SERVICE INFORMATION

Official Notification Under the U.S. Federal Boat Safety Act - Alpha One Delayed Shift

76616

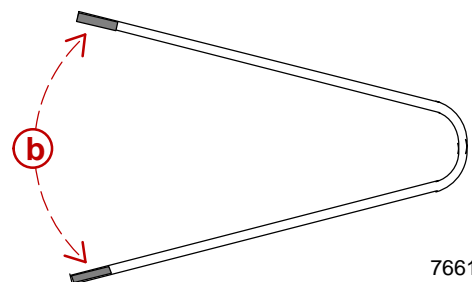
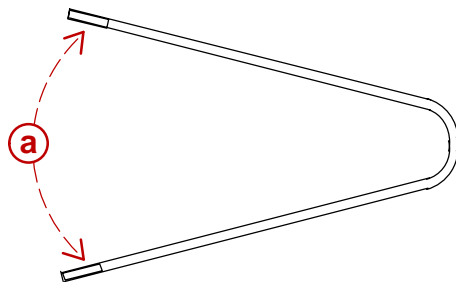
On these engines the shift plate assembly has a shift interrupt spring with the wrong tension. Incorrect tension can delay the shift from FORWARD or REVERSE to NEUTRAL.

When either hard shifting or delayed shifting has occurred, inspect the shift plate shift interrupt lever spring. If the unit falls within the above S/N range and the spring has either white or no markings, it must be replaced. If the spring has either blue or yellow markings on the ends, the correct spring has been previously installed. If the spring has blue tips, the lever will also be marked with a blue paint dot.

- a** - White Paint Or No Paint Indicates Replacement Necessary
- b** - Yellow Or Blue Paint Indicates Replacement Complete

Replace the shift interrupt spring on the shift plate with a Quicksilver replacement spring. The replacement spring will have a 1/2 in. (13 mm) yellow paint mark on the ends.

1. Install the new shift spring.
2. Install the shift interrupt lever assembly.
3. Ensure that the shift interrupt switch is centered in the "V" notch of the shift interrupt arm assembly.
4. Apply Loctite 277 to the 9/16 actuator lever bolt threads and install the bolt. Torque to 130 lb-in. (14.7 Nm).
5. Bend cotter pin to original position.
6. Install the engine flame arrestor cover and tighten locknut.
